# **Arborist Review**

## **Harris Green Village, 1045 Yates Street Victoria, BC**

Date submitted: Amended for November 13, 2020

Jobsite Property: Harris Green Village Development 1045 Yates Street

Site Plan Of:  
Lot A (DD 60683W) Of Lots 979 And 989, Plan 20163, And  
Lot 1 Of Lots 986 And 987, Plan 26779, And  
Lots 976, 977, 978, 980, 988, Victoria City.

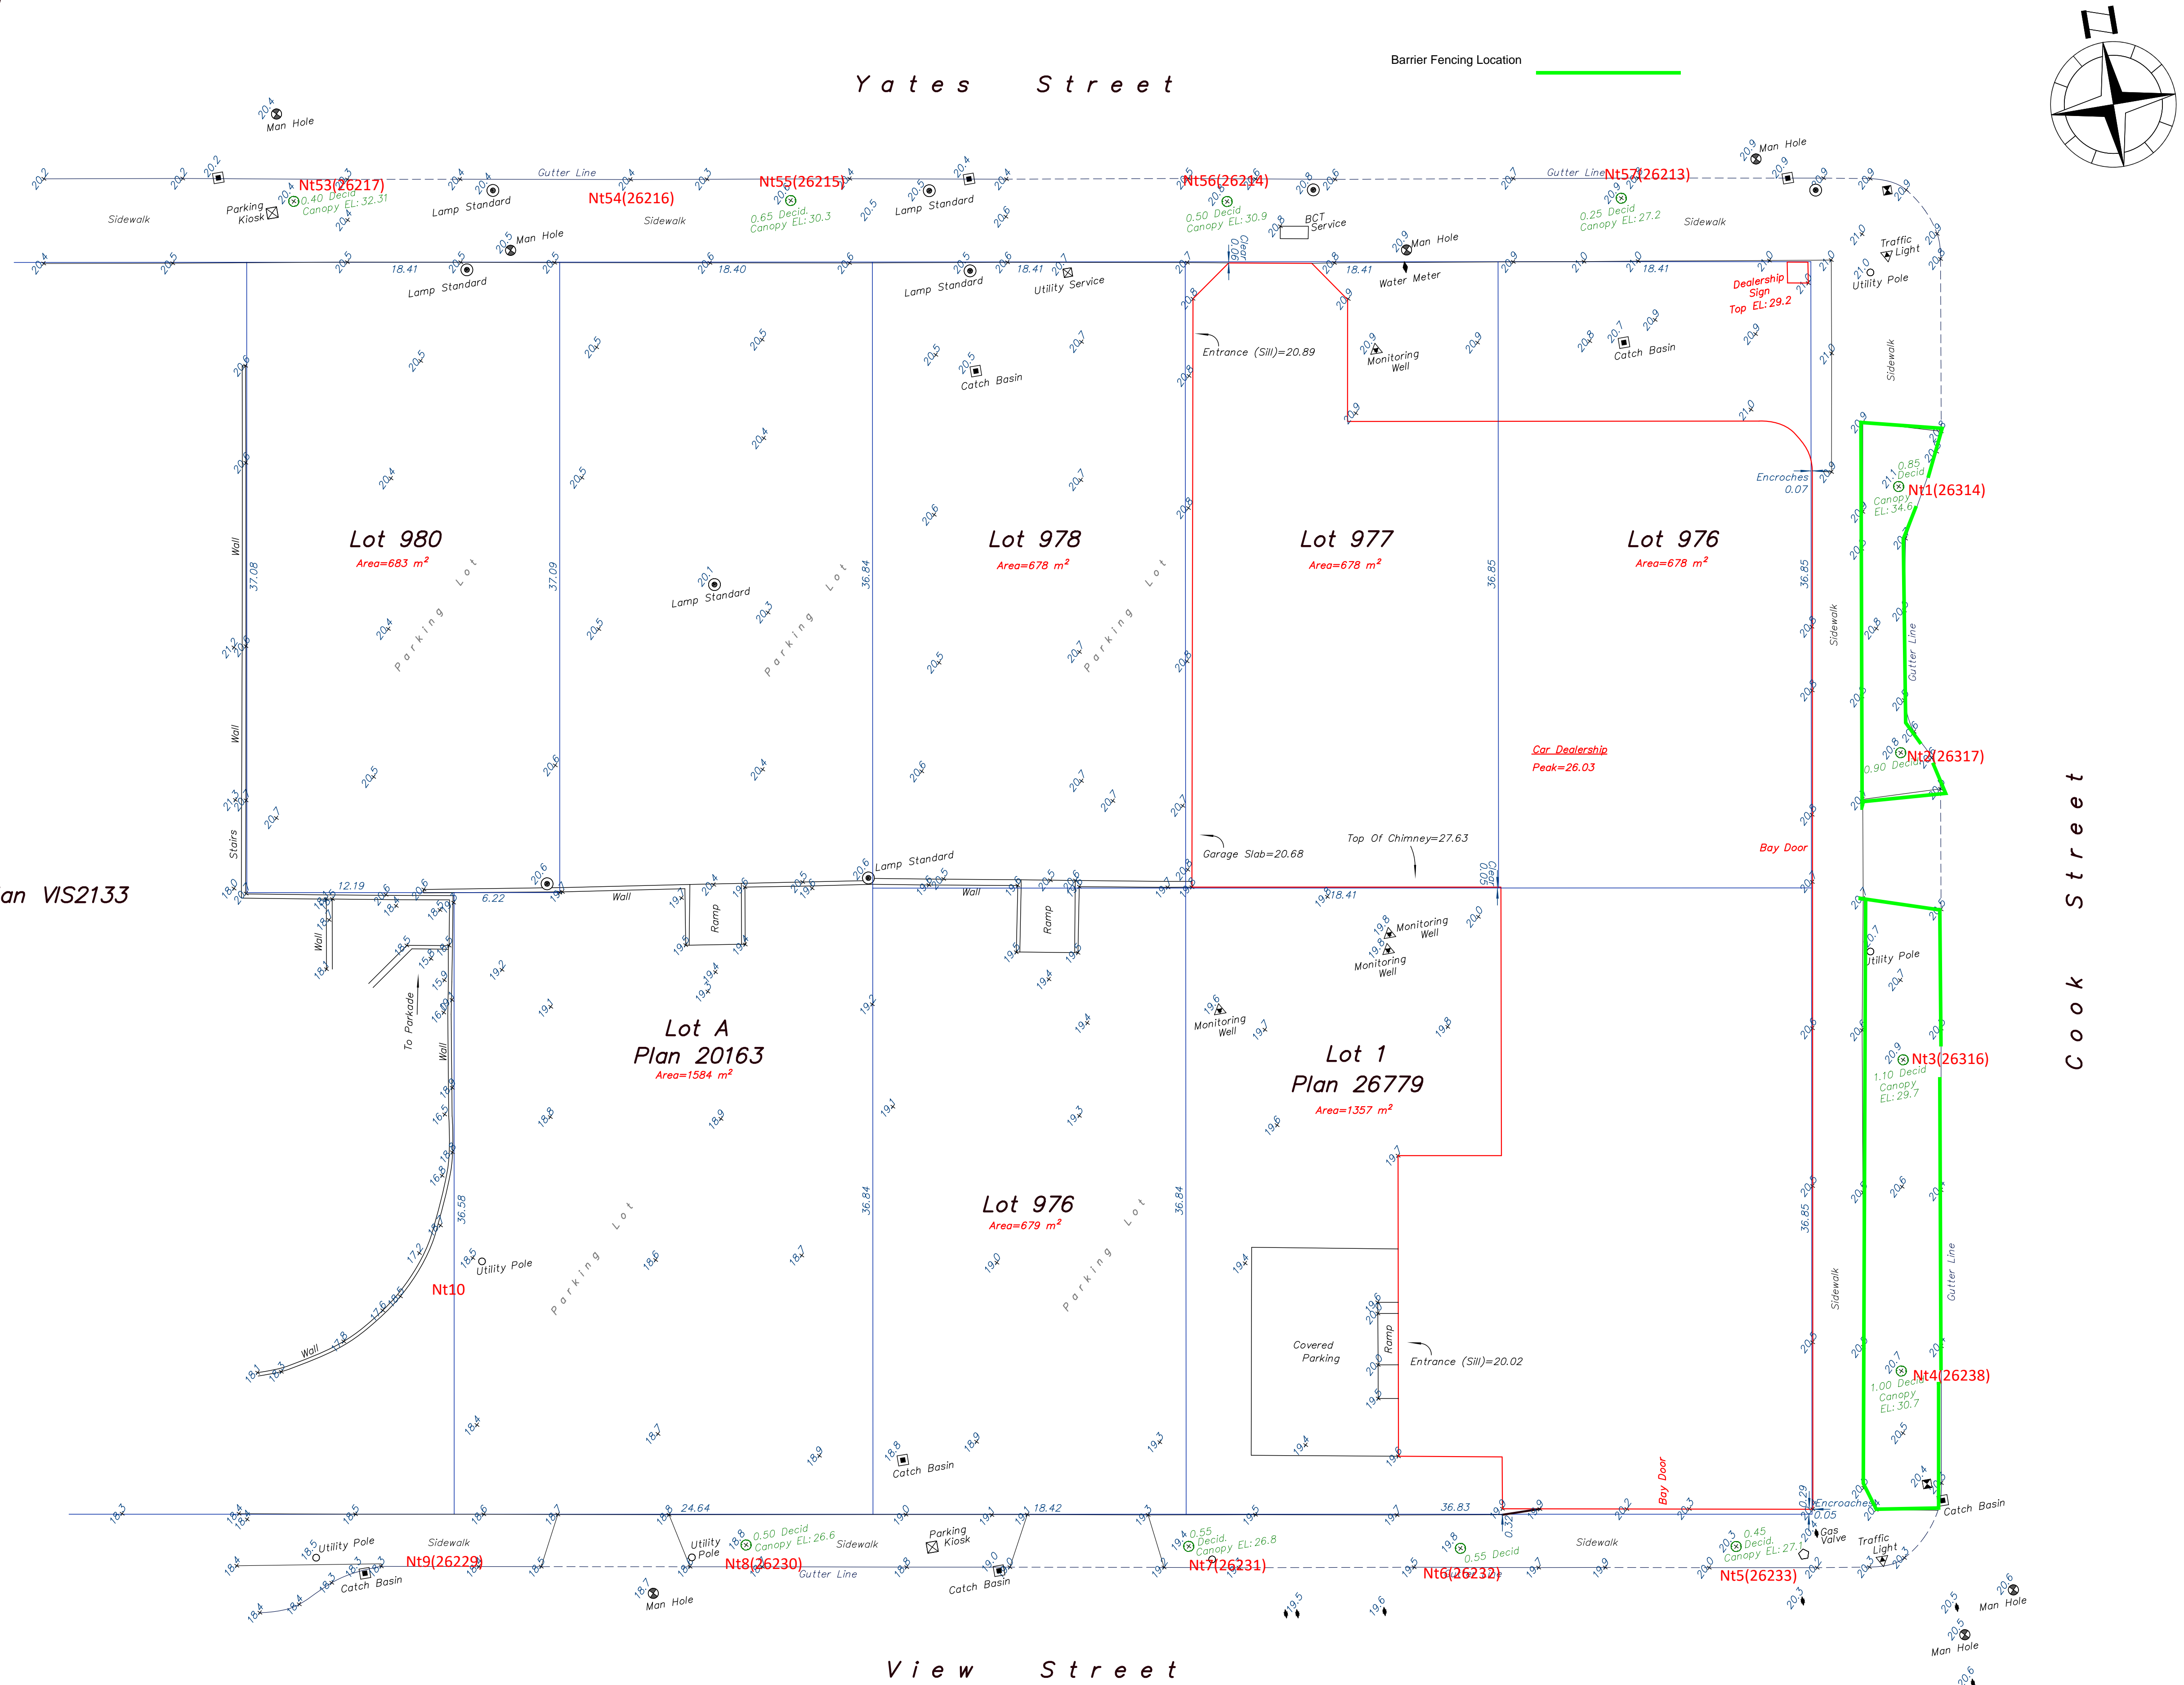
- The fire and domestic water and metre vault shown on the drawings that were reviewed are located on the Cook Street frontage and where the excavation required for the installation could be within 3 metres of Horse chestnut Nt4 (#26238) and where root structures are likely to be encountered. The Civil contractor suggested an alternate location for these connections that would be between Horse chestnut NT3 (#26316) and Nt4 (#26238). If the connections are located mid way between these two trees the required excavation required should be more than 7 metres away from both trees. This alternate location is the option that we prefer. Excavation to install the water connection and metre vault must be supervised by the project arborist. The existing water and irrigation services located along the Cook street frontage are to be capped and abandoned. If possible, these services should be capped inside the property boundary or at the service main. If the services are capped outside the property boundary the connections must be exposed by way of hydro excavation.

- Pruning: There is a slight overhang of the canopies of chestnut Nt3 (#26316) and Nt4 (#26238) of up to 2 metres or less on the project side of the trees where several of the lowest limbs trespass over the property boundary. The canopies of chestnut Nt1 (#26314) and Nt2 (#26317) extend up to or have a minor trespass over the property boundary. Pruning has been completed previously to restrict the upward growth of the limbs to below the height of the adjacent overhead hydro primary conductor. In our opinion pruning the canopies at the property boundary to reduce, the risk of accidental limb breakage during construction and future conflicts with the building structure will not have a detrimental impact on the health of these trees. Pruning can be accomplished without removing limbs greater than 10 cm in diameter and will result in the removal of less than 5% of the overall tree canopy. All pruning must be completed by an ISA Certified Arborist or to ANSI A300 standards.

- **Barrier Fencing:** Protective barrier fencing must be erected to protect the root zones of the municipal trees prior to any construction, excavation of demolition work commencing on the site. The fencing must surround the entire exposed areas of the root zones that are not covered with concrete and asphalt surfacing. It may also be necessary to erect barrier fencing to protect the View and Yates Street municipal trees if the demolition occurs prior to the approval of the building permit or the approval to remove these trees. Barrier fencing must be extended to surround the Cook Street sidewalk and driveway crossing once this hardscape surfacing is removed and remain in place until the sidewalk replacement construction occurs.  
The barrier fencing to be erected must be a minimum of 4 feet in height, of solid frame construction that is attached to wooden or metal posts. A solid board or rail must run between the posts at the top and the bottom of the fencing. This solid frame can then be covered with plywood, or flexible snow fencing (see attached diagram). Signs must be posted around the protection zone to declare it off limits to all construction related activity. The fencing must be erected prior to the start of any construction activity on site (i.e. site clearing, demolition, pavement removal, excavation, and construction), and remain in place through completion of the project. The project arborist must be consulted and the municipality notified before this fencing is removed or moved for any purpose. Solid hording material may also be required to protect the trunks of trees from mechanical injury where vehicles or machinery are permitted close to tree trunks.
